# Work Order ID 105227

Item Name: Crosstube Turning Detail

DART AEROSPACE LTD	Work Order:	105227
Description: Crosstube Assembly (412 High Aft)	Part Number:	D412-664-243
Inspection Dwg: D412-664-243 Rev: E		Page 1 of 2

DRAWING NO. D412-664-243		TITLE CROSSTUBE ASS'Y (412 HI AFT)		REV. E	DART AEROSPACE LTD ENGINEERING ORDER		D.E.O. NO. D412-664-243-E-2		SHEET NO. SHEET 1 OF 1		SCALE NTS
DRAWN <i>q</i>		CHECKED <i>ASS</i>		MFG. APPR. <i>E</i>		APPROVED <i>MP</i>		DE APPR. <i>H</i>			
DATE 11.09.07		DATE 11.09.19		DATE 11.09.19		DATE 11.09.19		DATE 11.09.19

DRAWING NO. D412-664-243	TITLE CROSSTUBE ASSEMBLY (412 HI AFT)	REV. E	DART AEROSPACE LTD ENGINEERING ORDER		D.E.O. NO. D412-664-243-E-4	SHEET NO. SHEET 1 OF 3	SCALE NTS
DRAWN 9	CHECKED A	MFG. APPR. A	APPROVED MP		DE APPR. MP		
DATE 12.08.21	DATE 12.08.30	DATE 12.08.30	DATE 12/8/30		DATE 12.08.30

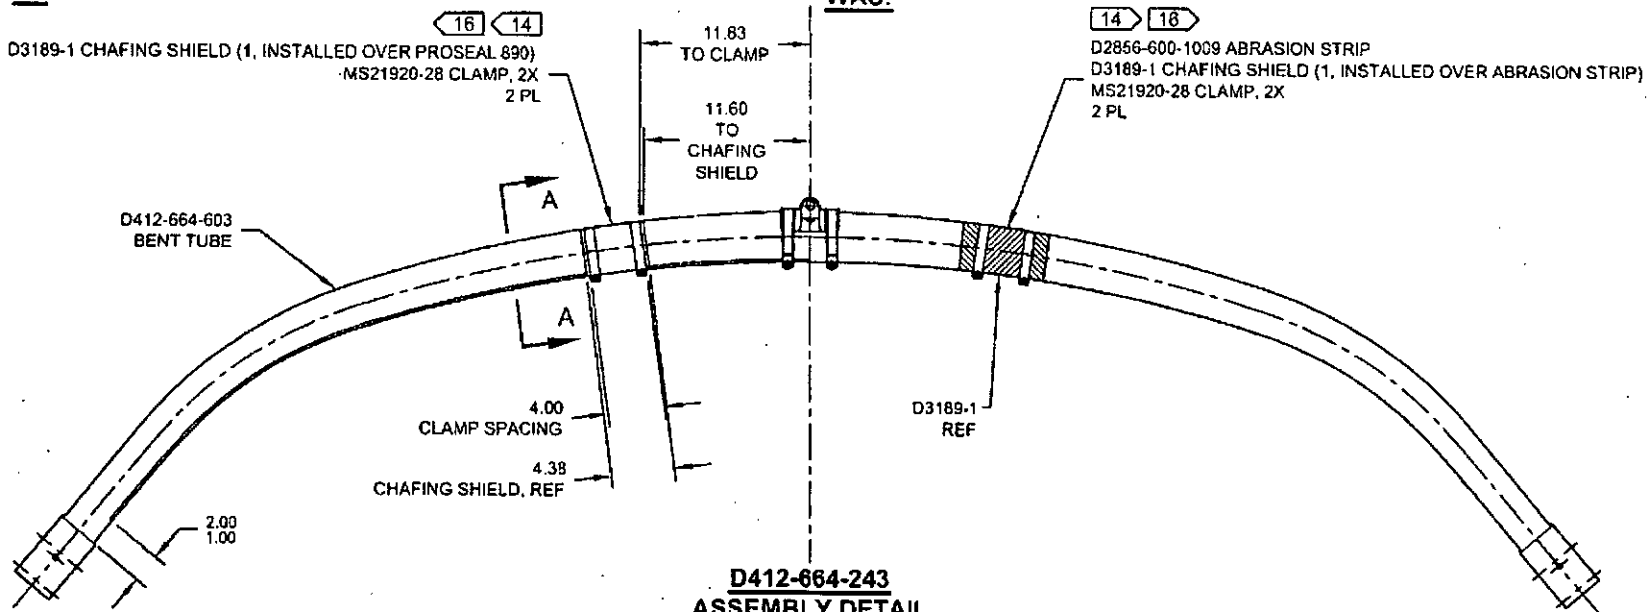
REMOVED ABRASION STRIP IN FAVOR OF A THIN LAYER OF PROSEAL 890. UPDATE INSTALLATION OF CHAFING SHIELDS AND REDUCE TORQUE TO 40-50 IN-LBS. THIS ENGINEERING ORDER SUPERCEDES DEO D412-664-243-E-1.

NOTES 2, 14, AND 16 ON SHEET 1 ARE AMENDED AS FOLLOWS:

- 2) FINISH: CHEMICAL CONVERSION COAT PER DART QSI 005 4.1  
PRIME INSIDE AND OUTSIDE PER DART QSI 005 4.2  
MASK UNDERSIDE OF CROSSTUBE AS SHOWN (HATCHED AREA)  
PAINT OUTSIDE PER DART QSI 005 4.2  
AFTER PAINTING, APPLY CLEAR COAT ON HATCHED AREA
- 14) APPLY A THIN COAT OF PROSEAL 890 ON INSIDE CONCAVE SURFACE OF D3189-1 CHAFING SHIELD AND LET CURE PER MANUFACTURER'S INSTRUCTIONS. INSTALL PROSEALED D3189-1 CHAFING SHIELD ONTO CROSSTUBE BY APPLYING A THIN COAT OF PROSEAL 890 ONTO CROSSTUBE. BE SURE TO ELIMINATE ANY AIR GAPS.
- 16) TORQUE CLAMPS ON D2896-1 SUPPORT 80 TO 100 IN-LB. **TORQUE CLAMPS ON D3189-1 CHAFING SHIELD 40 TO 50 IN-LB.** ENSURE AT LEAST 1.5 THREADS SHOWING IN SAFETY AND THAT NUT HAS NOT BOTTOMED-OUT AFTER TORQUING.

**D412-664-243  
ASSEMBLY DETAIL**

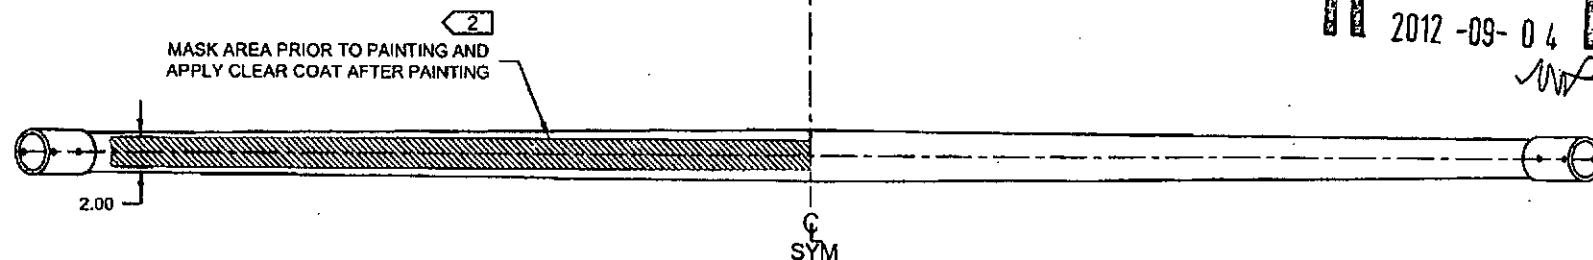
WAS:

14 18  
D2856-600-1009 ABRASION STRIP  
D3189-1 CHAFING SHIELD (1, INSTALLED OVER ABRASION STRIP)  
MS21920-28 CLAMP, 2X  
2 PL

IS:

16 14  
D3189-1 CHAFING SHIELD (1, INSTALLED OVER PROSEAL 890)  
MS21920-28 CLAMP, 2X  
2 PL
